Subject: VIRGIL C. SUMMER NUCLEAR STATION (VCSNS), UNIT 1
DOCKET NO. 50-395
OPERATING LICENSE NO. NPF-12
RESPONSE TO REQUEST FOR ADDITIONAL INFORMATION
CONCERNING 2012 ANNUAL ECCS EVALUATION MODEL
REVISIONS REPORT

**VIRGIL C. SUMMER NUCLEAR STATION, UNIT NO. 1 – RESPONSE TO REQUEST FOR
ADDITIONAL INFORMATION CONCERNING 2012 ANNUAL ECCS EVALUATION MODEL
REVISIONS REPORT (TAC NO. MF2722)**

Figure 1. V. C. Summer Baffle-Barrel Region Downflow Path

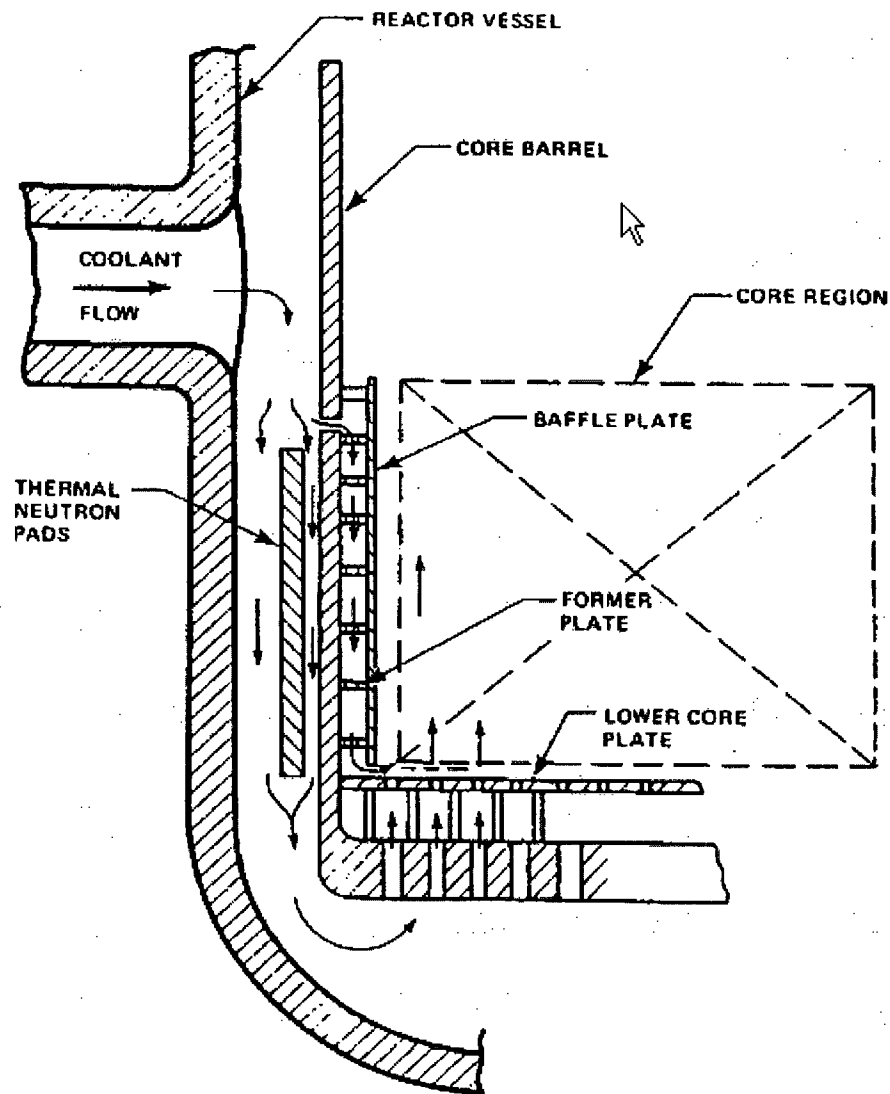
Provide a more detailed description of the upflow conversion and explain its implementation status.

During Cycle 16, V. C. Summer experienced fuel failure because of grid to rod fretting. This failure mechanism was initiated by reactor coolant cross-flow jetting through the joints between baffle plates. The susceptibility to this condition was due in part to the reactor internals flow configuration.

The V. C. Summer reactor vessel lower internals assembly consists of a core barrel into which baffle plates, supported by interconnecting former plates, are installed. The original reactor vessel internals configuration incorporated downward coolant flow in the region between the core barrel and the baffle plates as depicted in Figure 1. Since the flow direction through the baffle-barrel region was opposite to the direction of the flow through the core, there was an axial pressure gradient across the baffle plates, which varies from a maximum at the top of the core

to a minimum at the bottom of the core. This pressure gradient provided the driving force for cross flow jetting through the joints between baffle plates.

In order to substantially reduce the possibility of the baffle jetting, the reactor vessel internals were field modified during Refuel 18 (Fall 2009) to reverse the secondary coolant flow pattern in the baffle-barrel region in order to reduce the jet-driving pressure gradient across the baffle joints. The hardware change for this modification (i.e., Upflow Conversion), consisted of plugging the existing flow holes in the core barrel between the top and second former level and machining new flow holes in the top former plates. These changes resulted in a substantial reduction in the driving force for coolant jetting through the baffle plate joints. Section 4.2.2.2 of the V. C. Summer FSAR contains a brief description of the modification and its impact on the flow pattern within the baffle-barrel region.
